## **Certificate of Appropriateness**

## North Point North HD

4/22/2024

**2912 E Belleview Place**

Detail at top of chimney

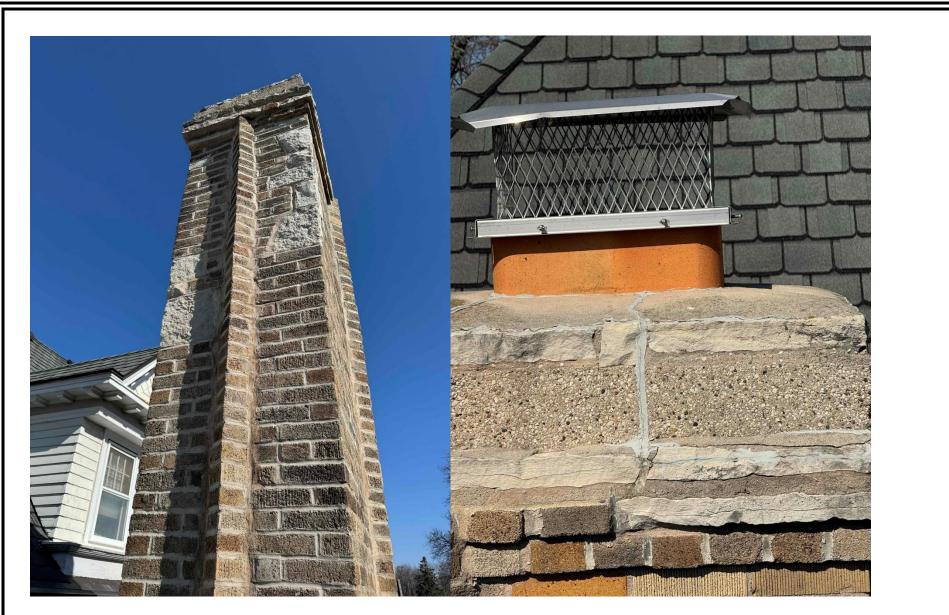
**Description of work** Install new concrete cap on chimney. There shall be a barrier layer of Type N mortar between the brick of the chimney and the new concrete cap. Corbelling must be rebuilt as it exists now with all stone pieces retained and reinstalled. Where brick is damaged, replace with matching rug-faced brick.

Chimney details. Note two complete courses of stone and one half course.

The (partially) rebuilt chimney must be rebuilt to exactly match the historic including bonding pattern, corbeling, and other details. Accurate measurements shall be taken prior to disassembling so the new chimney exactly matches the historic without alteration. When installing new flashing at a masonry feature, the flashing must be stepped or cut into the mortar joints. The bricks may not be cut to install flashing at an angle. New mortar must match the original mortar in terms of color, texture, grain size, joint width, and joint finish/profile. The compressive strength of the repointing mortar shall be equal or less than the compressive strength of the original mortar and surrounding brick or stone. The replacement mortar shall contain approximately the same ingredient proportions of the original mortar. Mortar that is too hard is subject to premature failure and could damage the masonry. In most cases, this means a lime mortar with natural hydraulic cement rather than Portland cement. No joint of a width less than 3/8" may be cleaned of damaged/decomposed mortar with power disc grinders. No over-cutting of the joints is permitted. Remove decomposed mortar back into the wall 2.5 times the height of the joint before repointing.
